Three Mile Island Nuclear Station Unit No. 1
Docket Number 50-289

Errata Sheet to responses to questions raised in Enclosure 2
of the NRC's 2-18-76 letter to TMI-1 concerning Appendix I

RESPONSES TO QUESTIONS RAISED IN ENCLOSURE 2

CONCERNING APPENDIX I

See attached Table 8-1 and Figures 8-1 through 8-16.

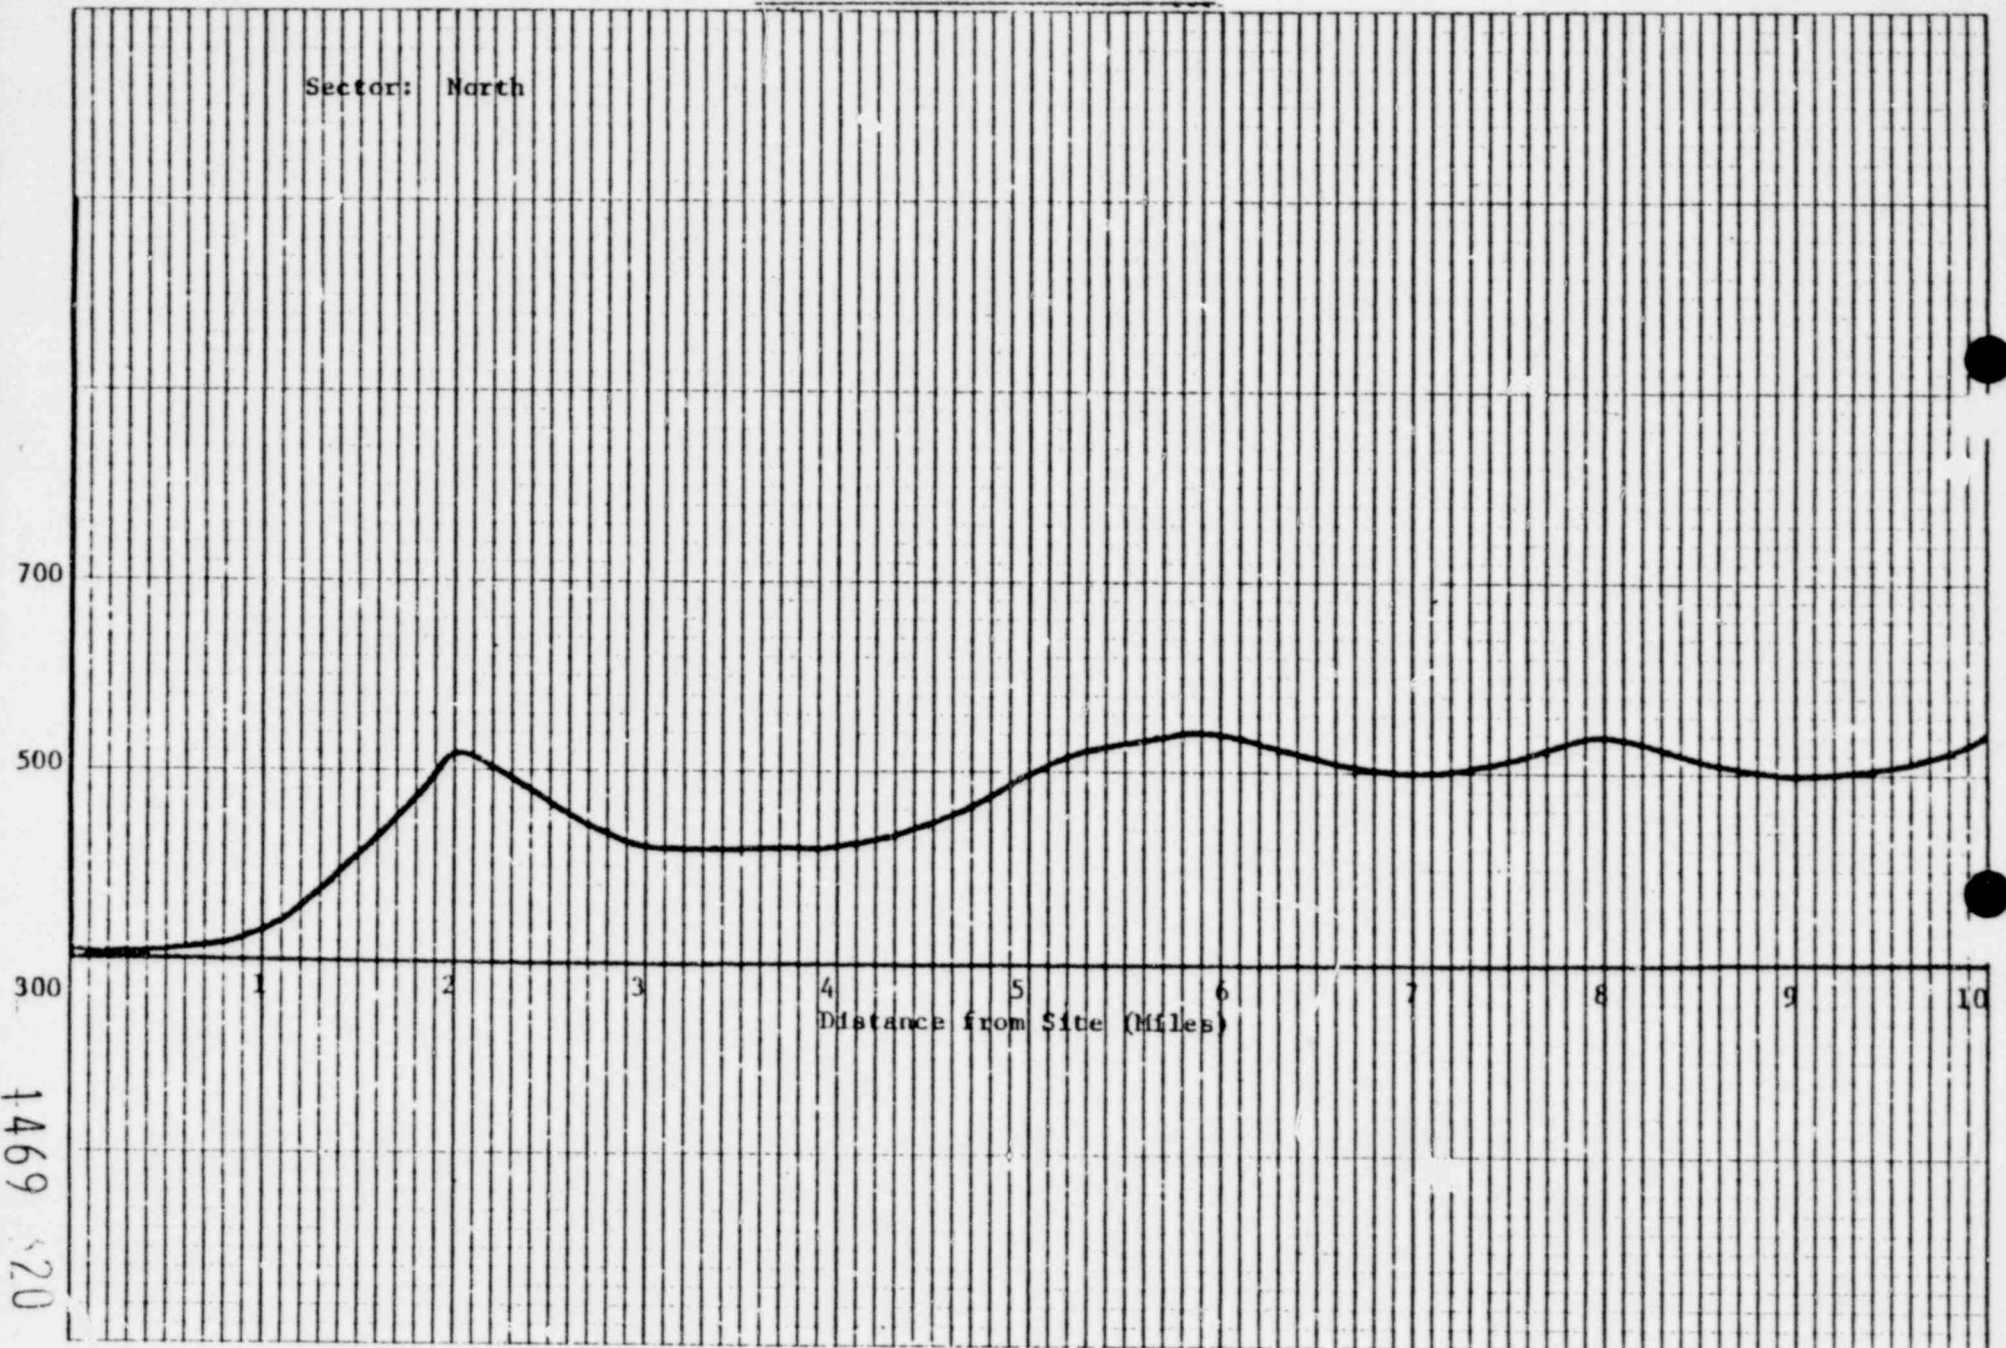
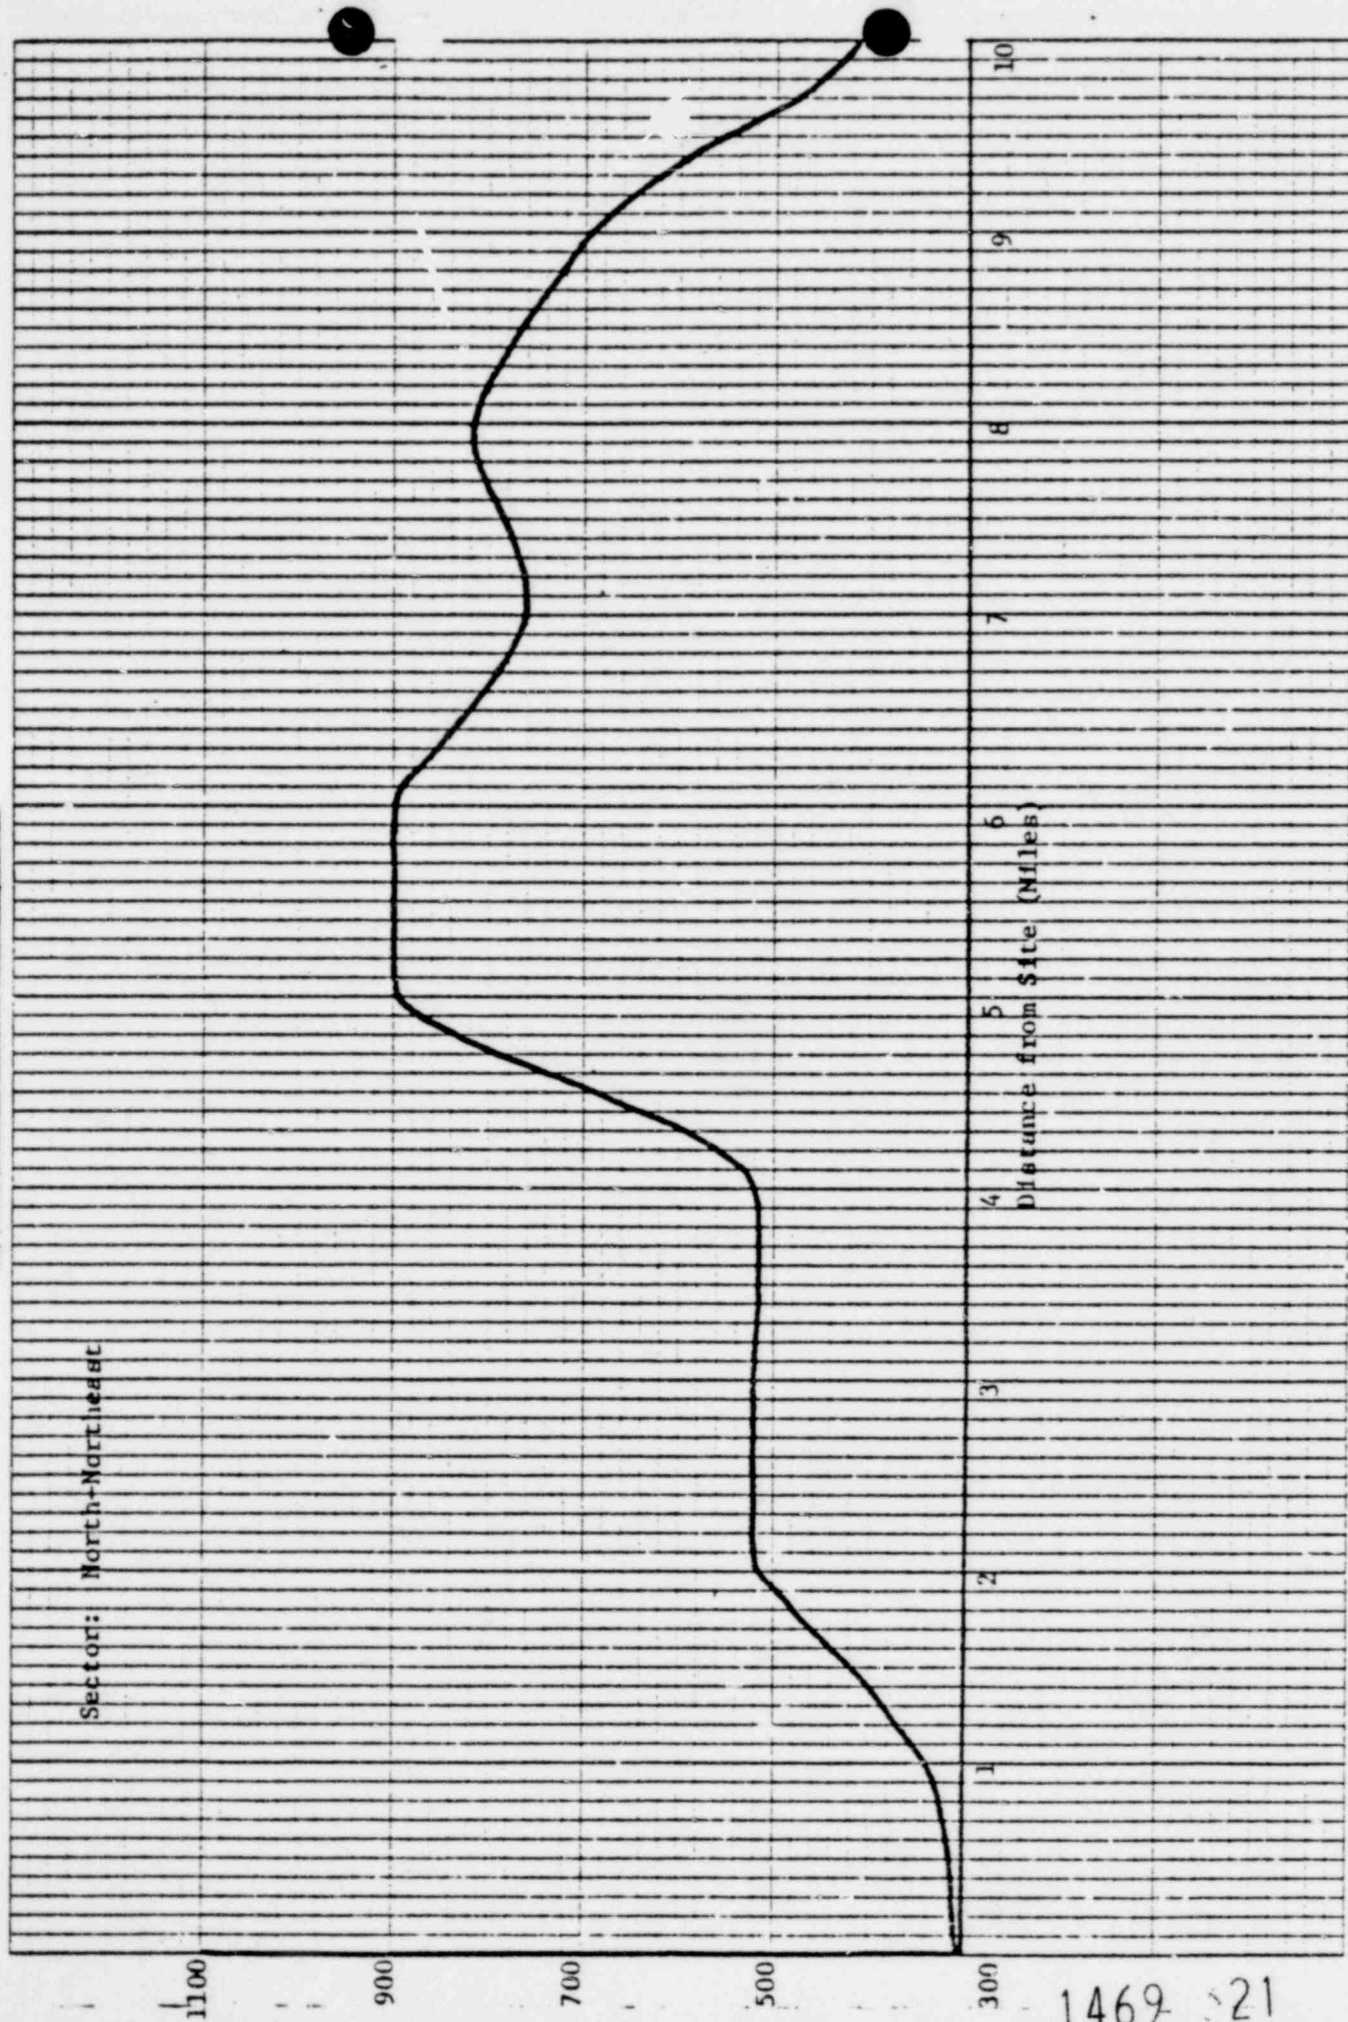
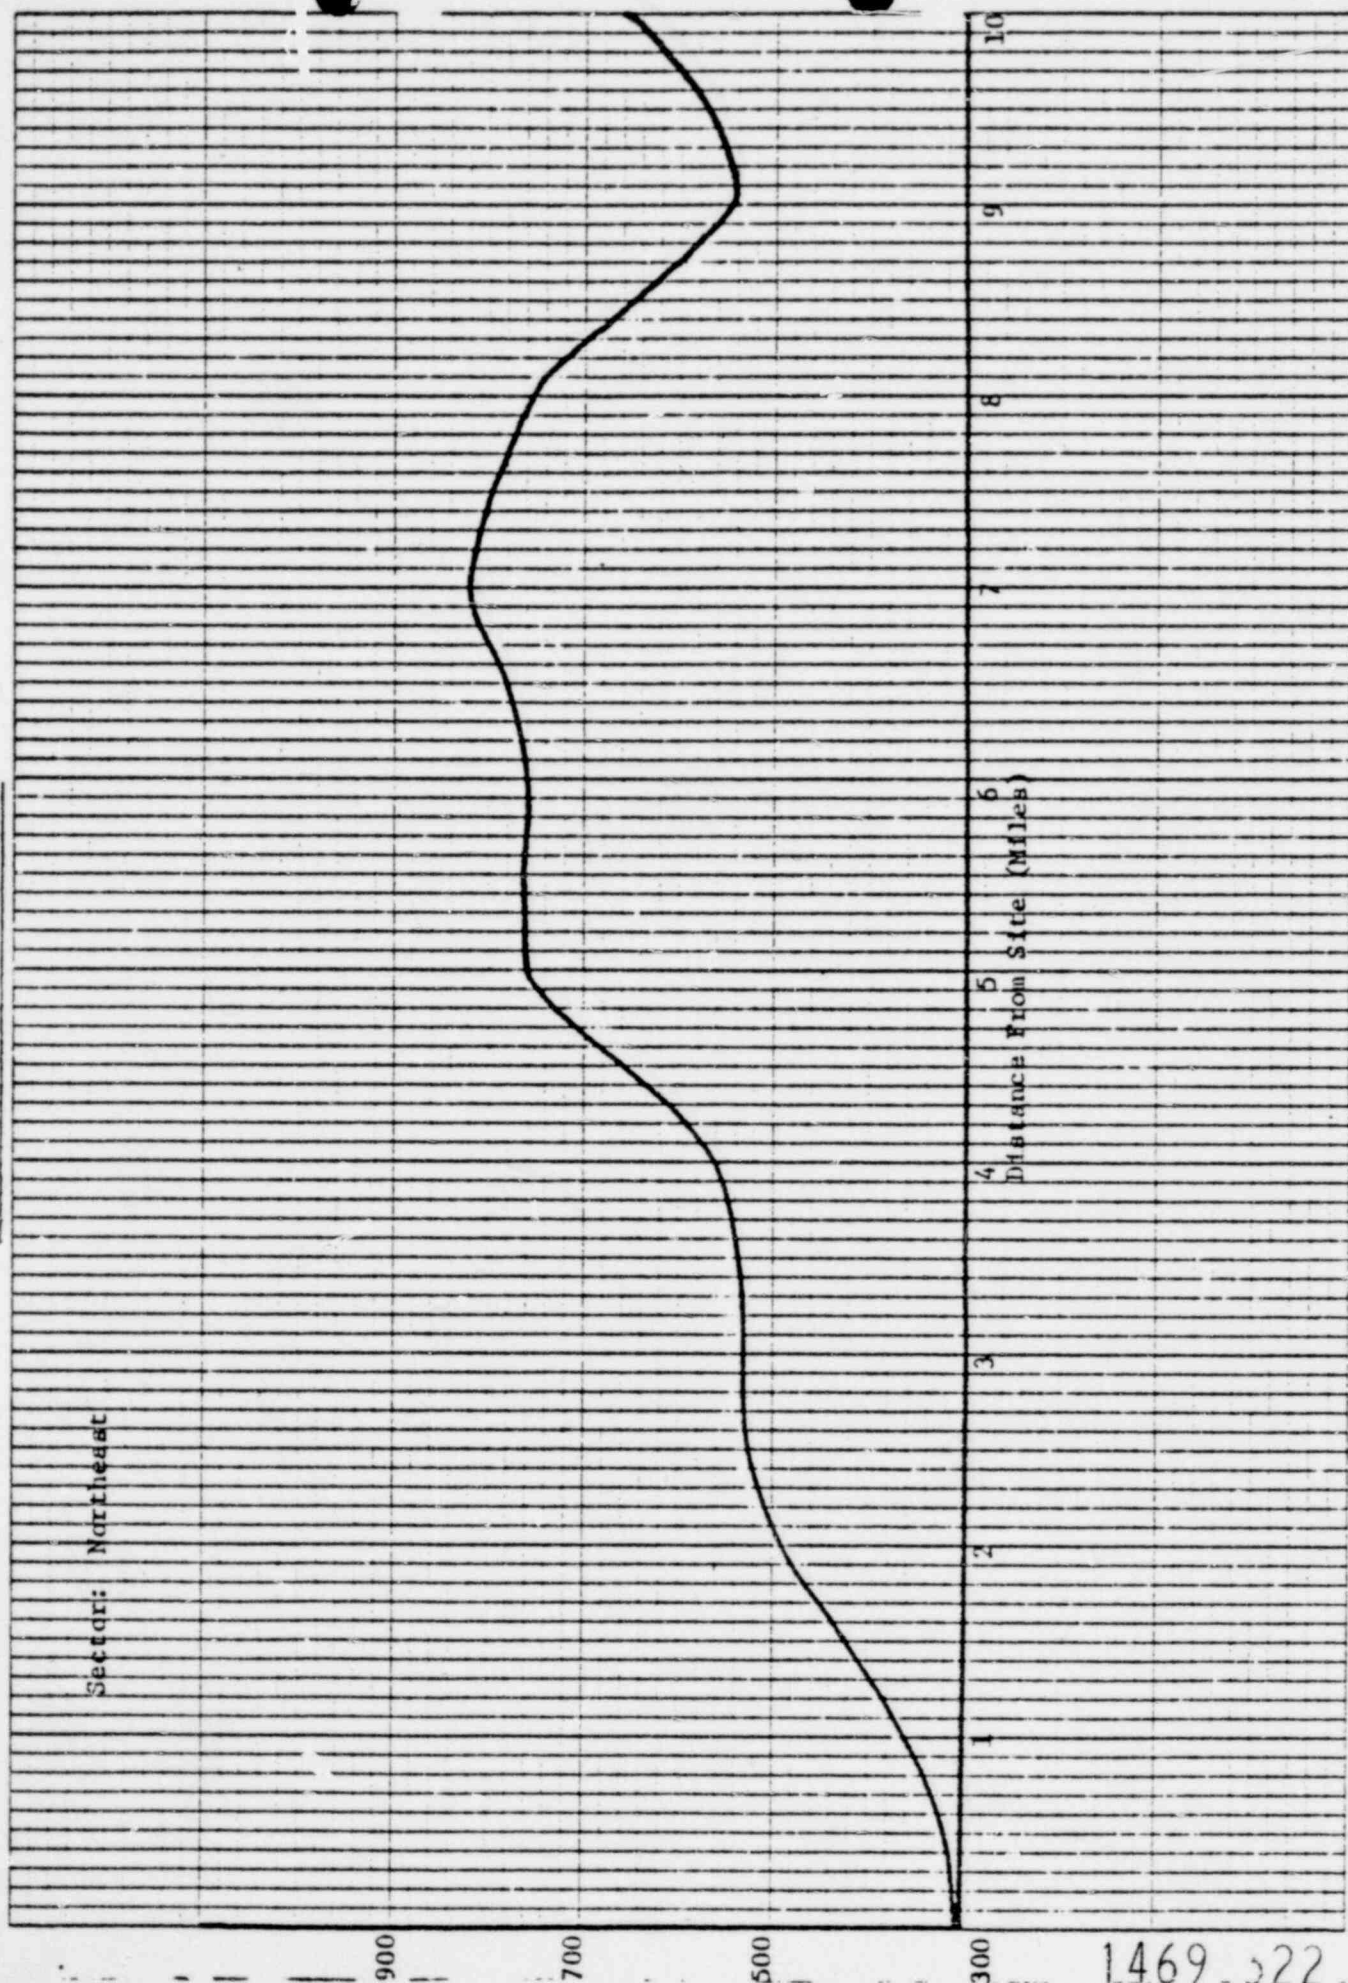
Provide a map showing the detailed topographical features (as modified by the plant) on a large scale, within a 10-mile radius of the plant and a plot of the maximum topographic elevation versus distance from the center of the plant in each of the sixteen 22-1/2 degree cardinal compass point sectors (centered on true north), radiating from the center of the plant, to a distance of 10 miles.

RESPONSE
